**Addendum No. 1**

**Subject:** General Louis Wagner Middle School Culinary Art Suite Renovation  
SDP Contract Nos. B-022C, B-023C, B-024C, B-025C

**Location:** General Louis Wagner Middle School  
1701 W Chelton Ave  
Philadelphia, Pennsylvania 19139

**This Addendum, dated 1 of April, 2021, shall modify and become part of the Contract Documents for the work of this project. Any items not mentioned herein, or affected by, shall be performed strictly in accordance with the original documents.**

**3 DETAIL PLAN - VCT PATTERN**  
SCALE: 3/8" = 1'-0"

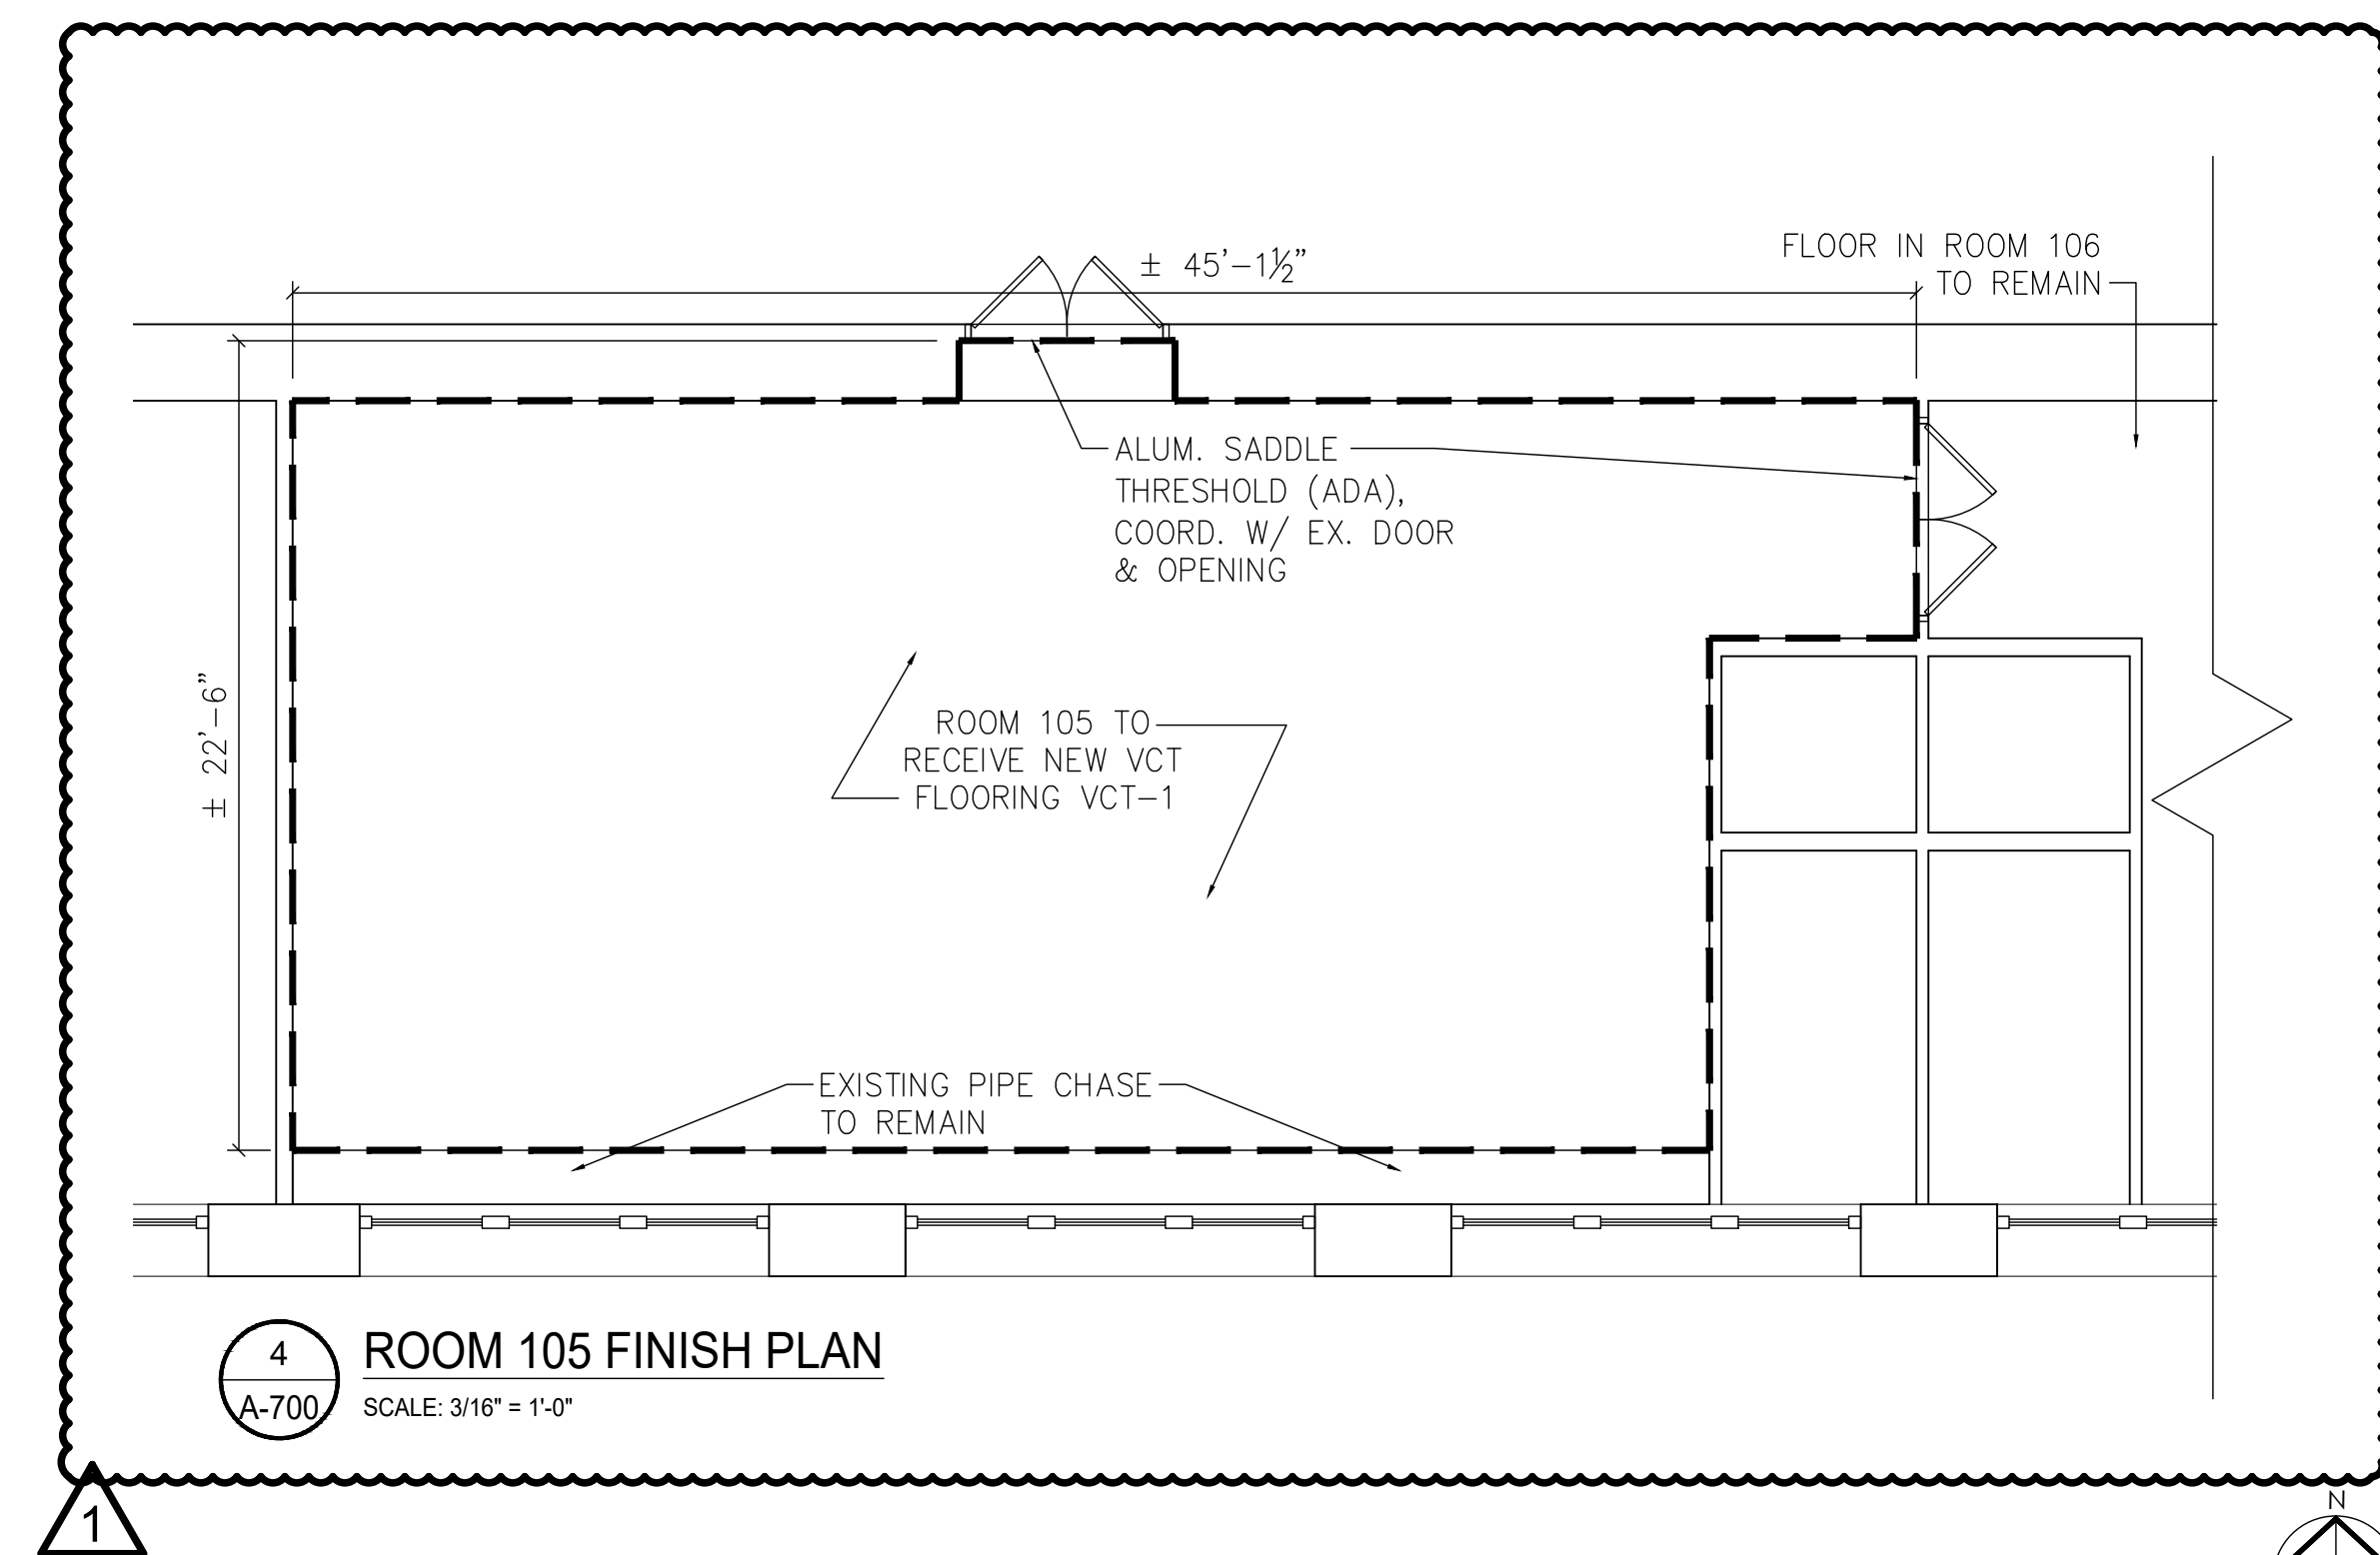
#### **Drawing: A-700 Finish, Furniture, and Equipment Plans**

- a. Add new detail: Detail 4 / A-700- Room 105 Finish Plan, refer to revised drawing.

Question 4: Asbestos report has floor in room 105&106 being removed, but not shown on finish schedule to replace with new VCT.

Question 5: Are the appliances listed on drawing part of GC scope of work?

**Answer 4: New VCT is to be provided for Room 105, see detail 4 on revised sheet A. Please note flooring in Room 106 has already been replaced and is to remain.**

**Answer 5: Yes, appliances listed on A-700 are part of GC scope of work.**

**1 ROOM 209 AND 210 MECHANICAL DEMOLITION PLAN**  
SCALE: 1/4" = 1'-0"

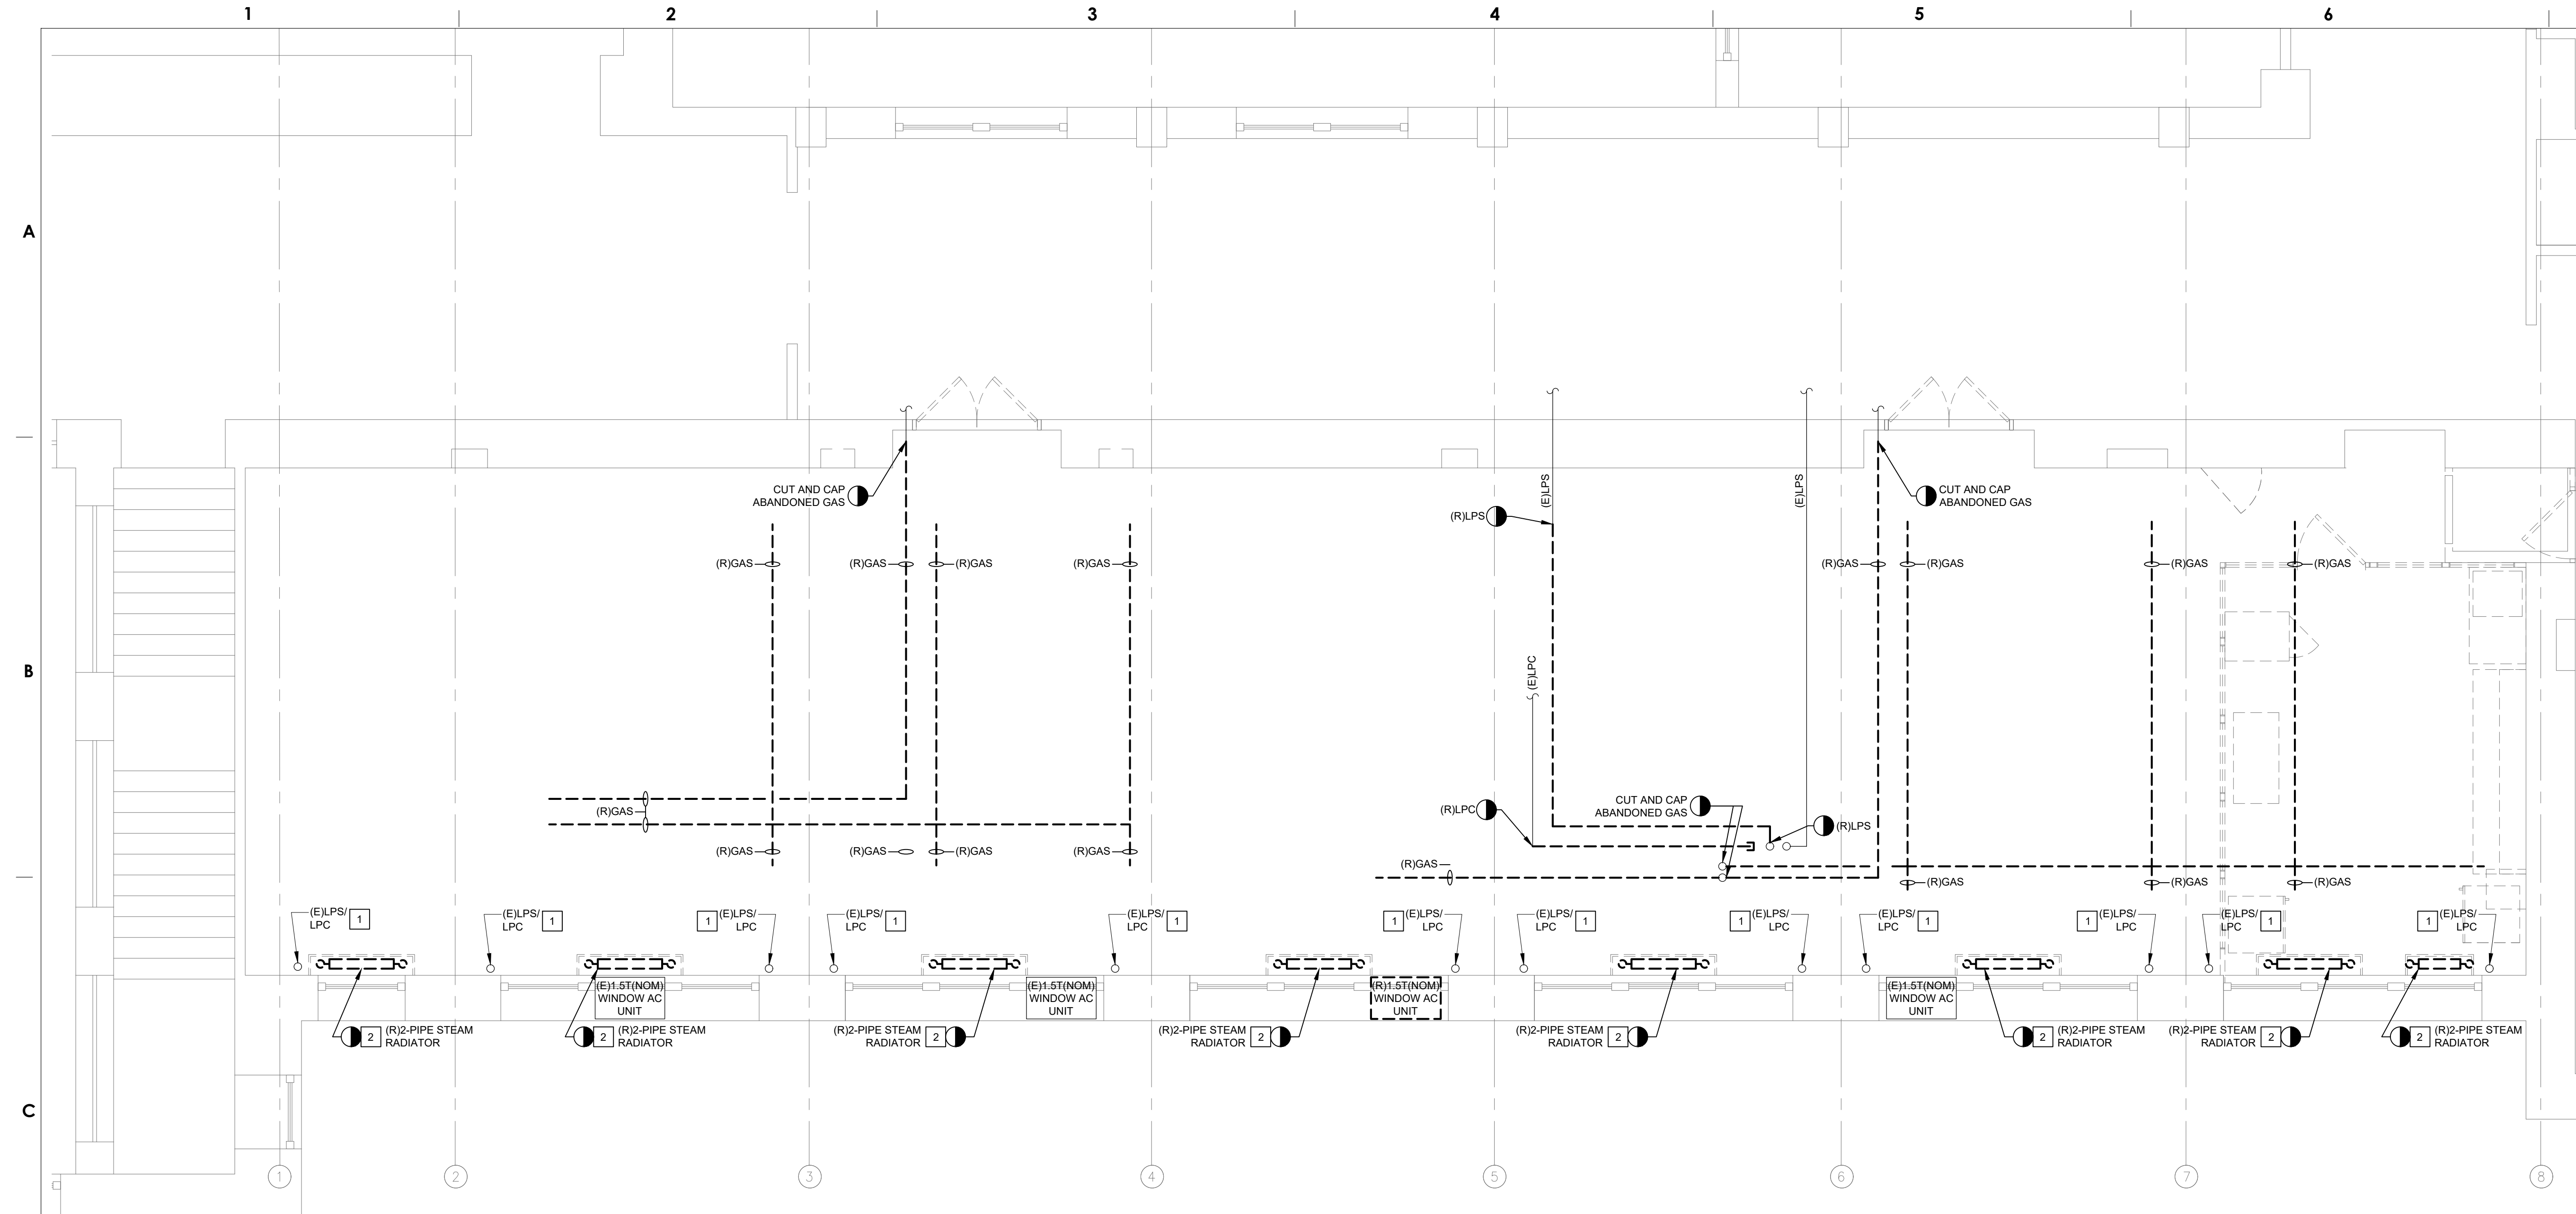
#### **Drawing: M-200 Room 209 and 210 Demolition Plan**

- a. Revised sheet note #2.

**1 ROOM 209 AND 210 MECHANICAL NEW WORK PLAN**  
M-300 SCALE: 1/4" = 1'-0"

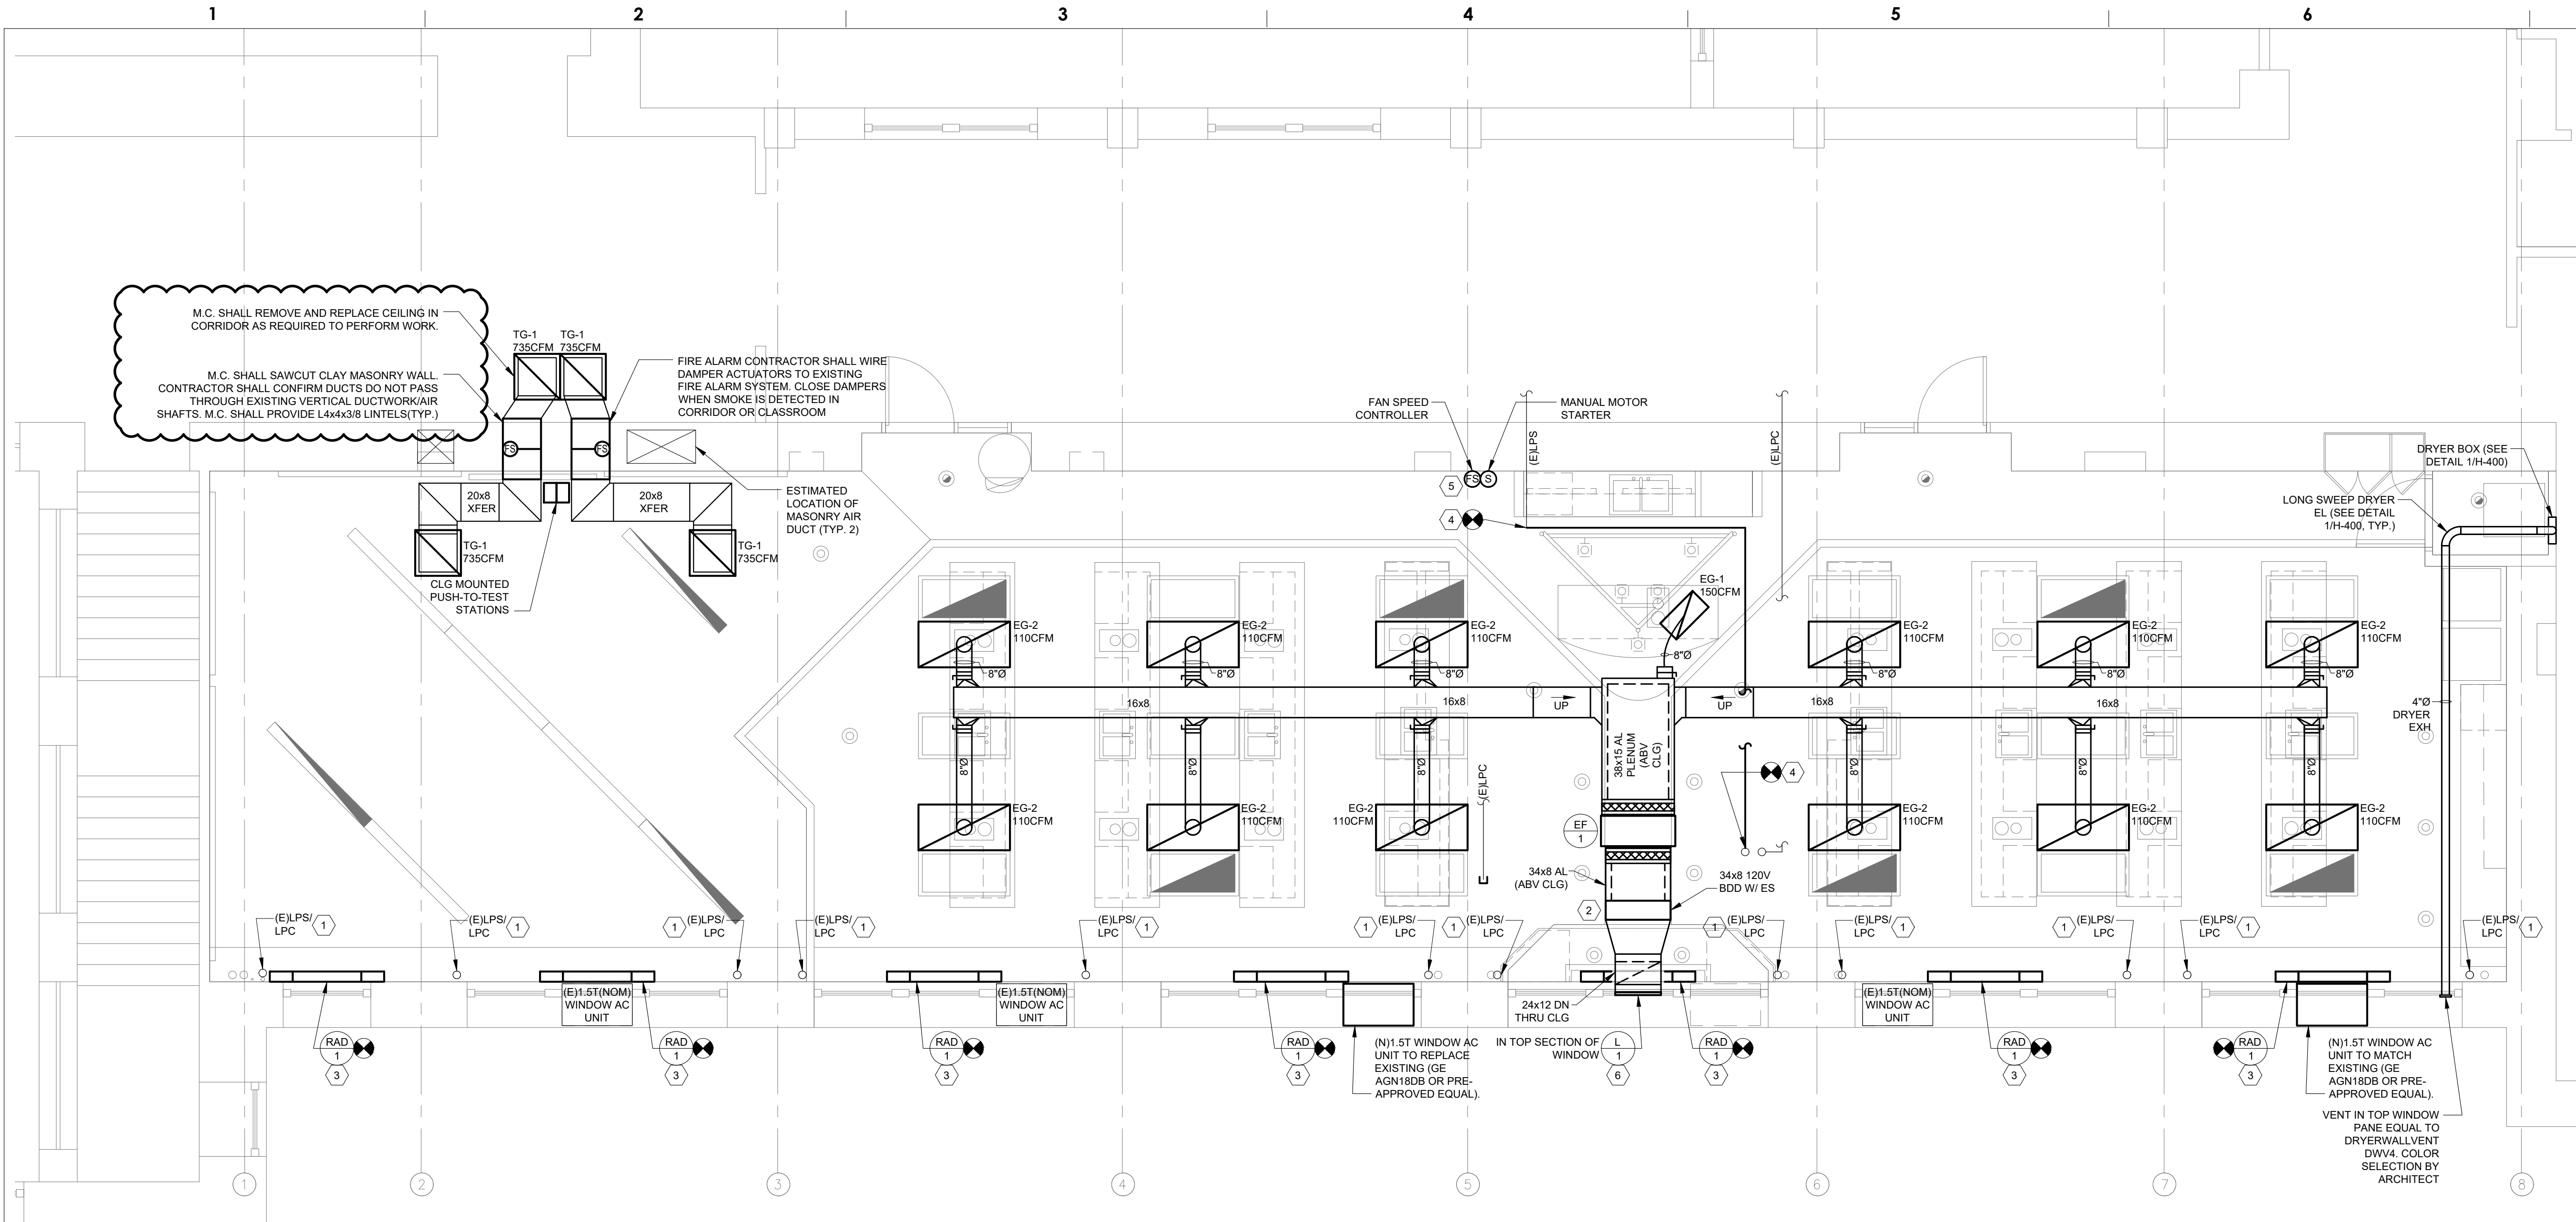
#### **Drawing: M-300 Room 209 and 210 New Work Plan**

- a. Added pipe insulation requirements.
- b. Modified notes for ceiling and masonry work in corridor.

THIS CONTRACTOR SHALL PROVIDE NEW PIPING INSULATION (FOR STEAM/CONDENSATE AND DOMESTIC WATER PIPING) WHERE EXISTING INSULATION IS ABATED (ABATEMENT BY OTHERS). PROVIDE NEW PREFORMED MINERAL FIBER INSULATION WITH ASJ JACKET TO REPLACE EXISTING. REFER TO MECHANICAL AND PLUMBING SPECIFICATIONS FOR INSULATION THICKNESS (CONFIRM PIPE SERVICE IN FIELD).

- PROJECT AREA (ROOM 209):
  - REPLACE FOR 21 ELBOWS ABOVE CEILING
  - REPLACE 20 LINEAR FEET ABOVE CEILING
  - REPLACE FOR 12 LINEAR FEET FOR VERTICAL PIPE IN EXISTING KITCHEN CORNER
- ROOM ADJACENT TO PROJECT AREA (ROOM 211A):
  - REPLACE FOR 4 ELBOWS ABOVE CEILING
  - REPLACE FOR 12 LINEAR FEET ABOVE CEILING
- ROOM ADJACENT TO PROJECT AREA (ROOM 211C):
  - REPLACE FOR 12 LINEAR FEET
  - REPLACE FOR 15 LINEAR FEET ABOVE CEILING
- ROOMS BELOW PROJECT AREA (ROOMS 105 & 106):
  - REPLACE FOR 270 LINEAR FEET OF "PIPE INSULATION AND ELBOW SYSTEM"
